TVA-SQN-TS-03-06

**SEQUOYAH NUCLEAR PLANT (SQN) - UNIT 2 - TECHNICAL
SPECIFICATIONS (TS) CHANGE 03-06 - CHANGE INSPECTION SCOPE
FOR STEAM GENERATOR (SG) TUBES**

TENNESSEE VALLEY AUTHORITY SEQUOYAH NUCLEAR PLANT (SQN) UNIT 2

Figure 4.1

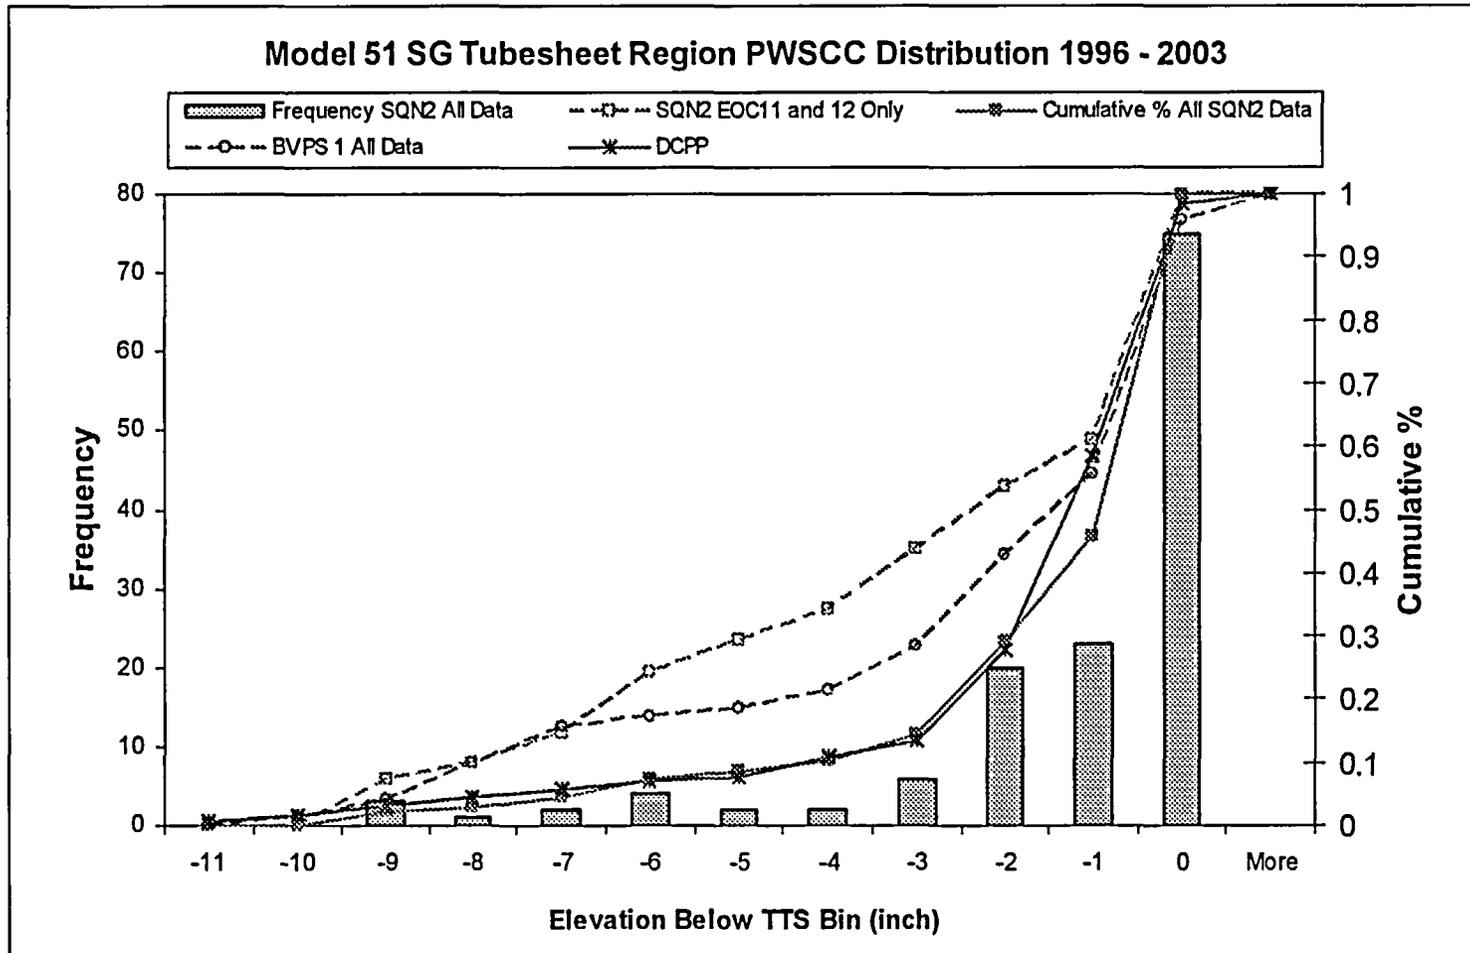
Figure 4.1 presents a cumulative distribution plot of elevations of all PWSCC indications reported at SQN2. Since elevation information is not available for the EOC-7 and earlier outages, the total number of indications reported from these outages were assigned to elevation bins based on the elevation distribution for the EOC-8 and later outages. This plot clearly shows that the PWSCC initiation potential is significantly greater for the top of tubesheet region than at deeper elevations. Recall that for the EOC-10 and all early outages, the +Pt inspection distance below TTS was 2 inches while for the EOC-11 and EOC-12 outages the +Pt inspection distances below TTS were 5.5 and 8 inches respectively. Figure 4.1 shows no increased initiation potential for indications at deeper elevations below TTS.

Figure 4.1 also presents cumulative distribution data of PWSCC as a function of elevation for the EOC-11 and EOC-12 outages only. For these outages, the inspection information for tube lengths never inspected can be used to formulate a judgment regarding indication potential at greater than 8 inches below TTS. At EOC-11, 26 total indications were reported with 14 located at greater than 2 inches below TTS, which was the bottom of the test extent for the EOC-10 outage. At EOC-12, 15 total indications were reported with 7 reported within 2 inches of TTS, zero reported between 2 and 5.5 inches below TTS (the bottom of text extent for the EOC-11 outage), and 8 reported at greater than 5.5 inches below TTS. The lack of new initiates in the 2

The elevation distributions for all data and the EOC-11/EOC-12 data are quite similar, further supporting the argument that PWSCC initiation potential below the transition region is far less than for the transition region. Note that for these plots, indication elevations between 0.00 and 0.99 inch below the top of tubesheet are found in the 0 inch bin. The SQN2 cumulative elevation distribution was compared against that of other plants with Model 51 SGs. The distributions for all plants are quite similar. Figure 4.1 also includes the Diablo Canyon Power Plant and Beaver Valley Power Station distributions which are similar to SQN2.

Figure 4.2

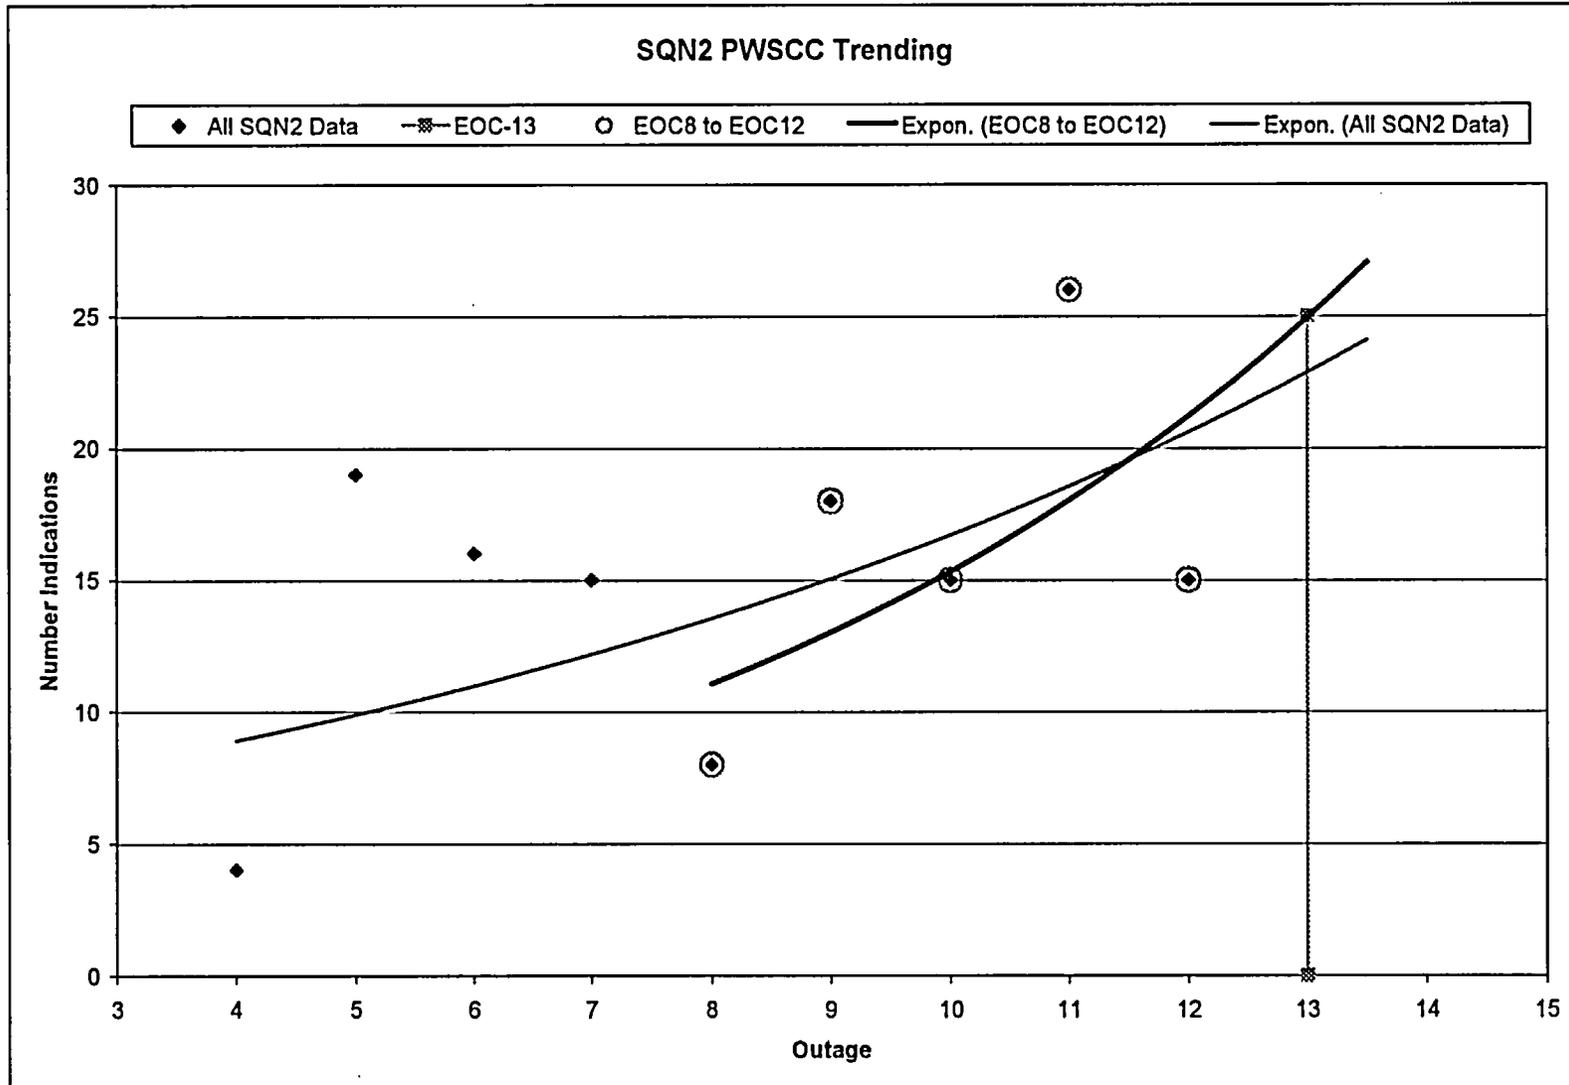
To date, 138 total indications have been reported, only 25, or 18%, of which were circumferentially oriented. Figure 4.2 illustrates the individual indication totals by outage. A regression analysis using all of the data suggests that approximately 23 indications are expected for the EOC-13 outage. Using only data from the last four outages, 25 indications are anticipated using a regression specific to that dataset. Therefore, the cumulative SQN2 total number of indications including the EOC-13 projection is a maximum of 163 (138 plus 25). An additional 41 indications (25% of combined historical indications plus EOC-13 new indications) might be observed if the inspection distance were increased from 8 to 12 inches below TTS. A very small number of these 41 postulated indications between 8 and 12 inches below TTS would be expected to have all of the following characteristics;

Figure 4.3

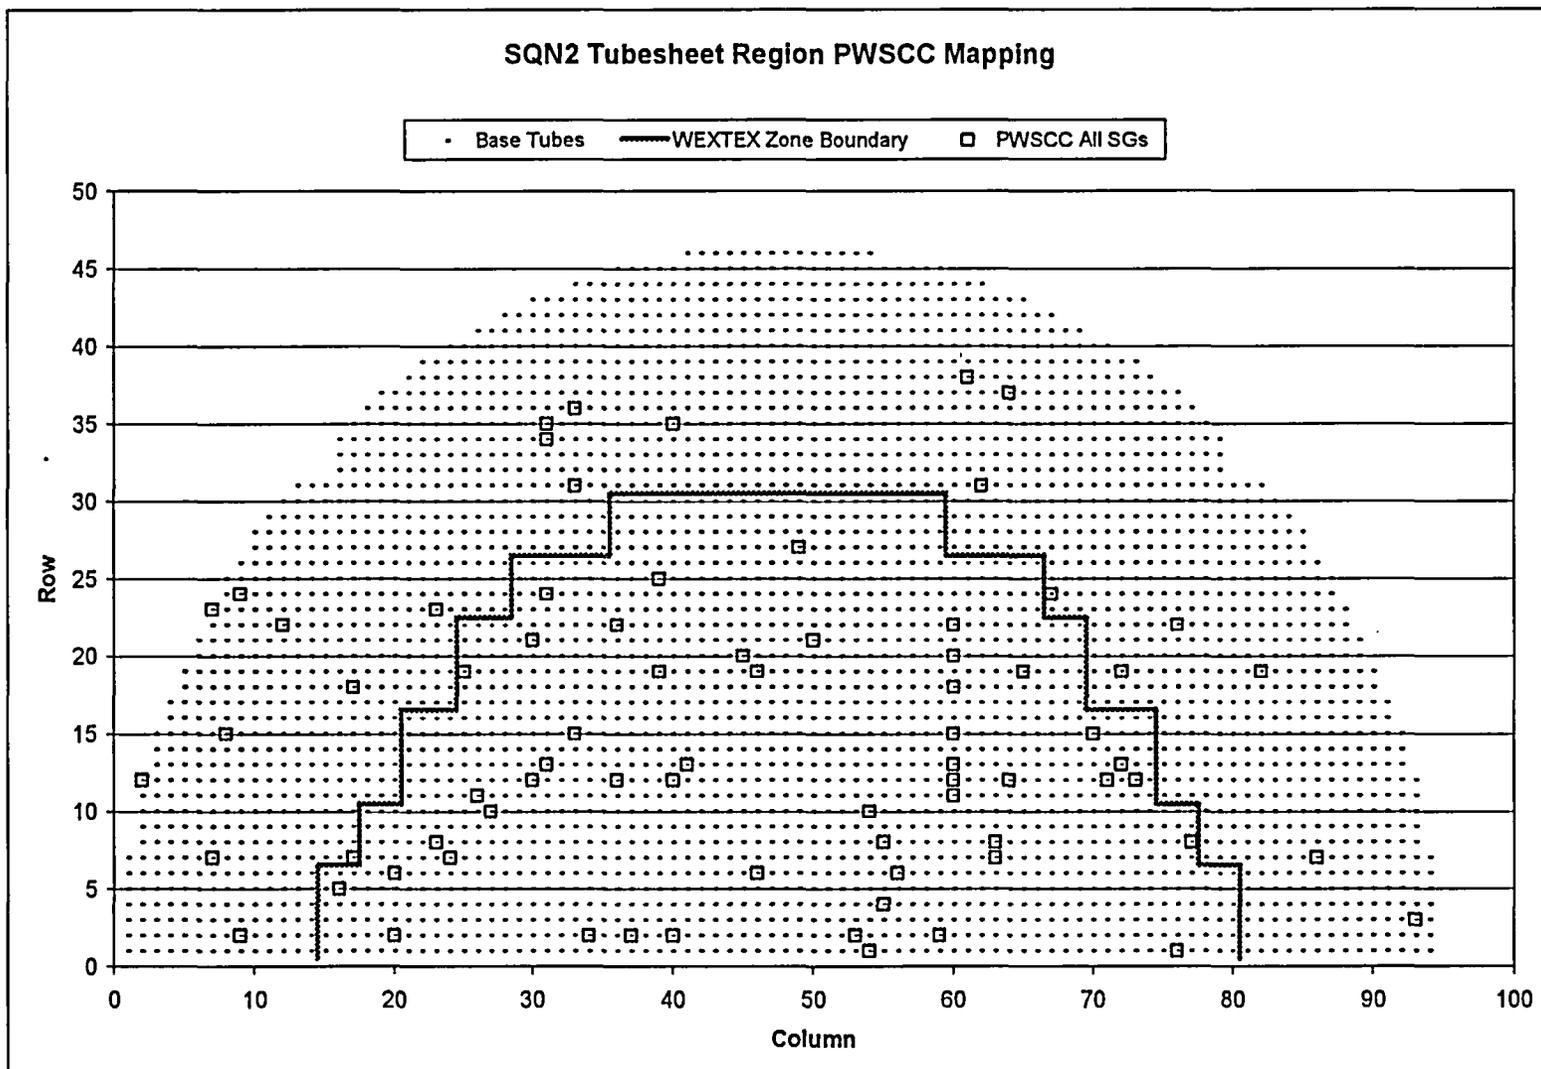
Figure 4.3 presents a tubesheet map plot of all Unit 2 PWSCC indications reported at EOC-8 and later. A total of 22 of the 82 indications in this population are reported to be in the outboard region, defined as Zone A, which is the zone with the lesser amount of tubesheet deflection during operating or faulted conditions.

Figure 4.4

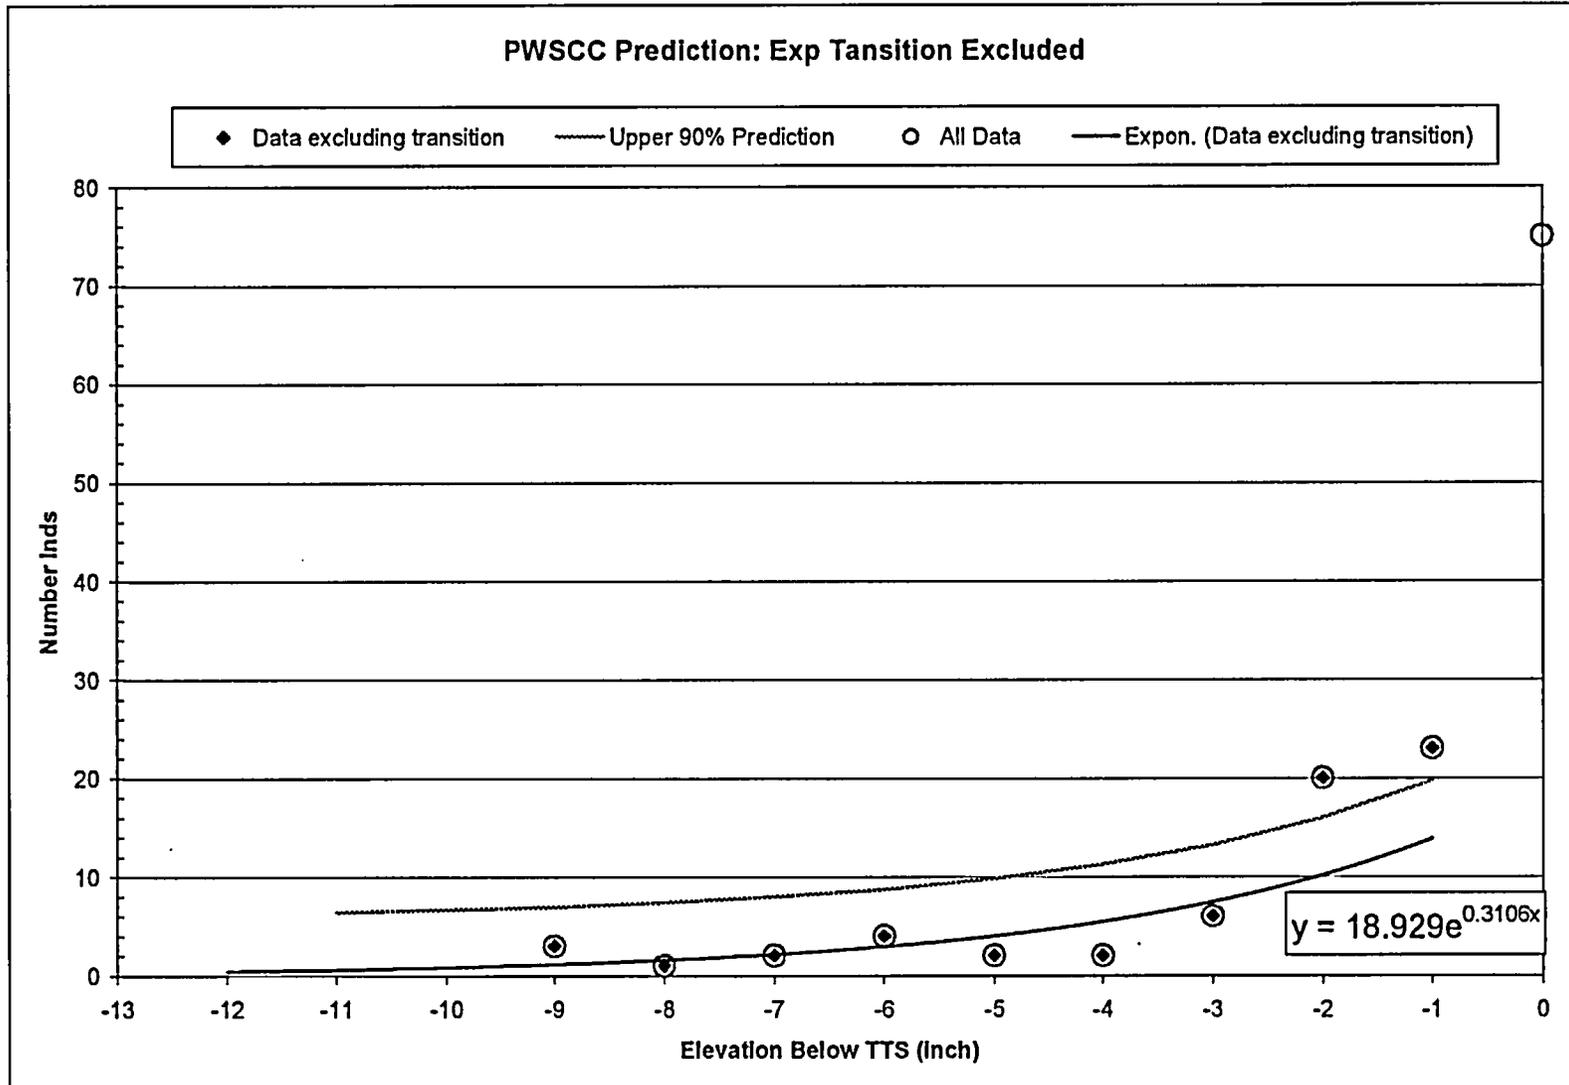
The above data were developed using the nominal inspection distance below TTS of 2, 5.5, or 8 inches, based on the outage chronology. In actuality, the inspection distance applied to each tube exceeds the specified value. This is purposely done during the data collection process to ensure that the appropriate distance is examined. This is shown by the deepest reported indications which reside at about 9.5 inches below TTS. Figure 4.4 presents a plot of the binned PWSCC elevation data for all historical indications with and without the expansion transition indications. Excluding the expansion transition indications would be expected to provide the best dataset for estimating indications at deeper depths. A best fit regression of the data with the expansion transition excluded is included in this plot. This plot shows that the predicted number of indications in each bin is only 1 for 1 inch increment bins greater than 11 inches below TTS.

Figure 4-4 also includes an upper 90% probability prediction bound for this data. The 95% prediction correlation suggests approximately 27 indications would be expected at > 8 but < 12 inches below the TTS. For conservatism, the previously established value of 41 will be applied.
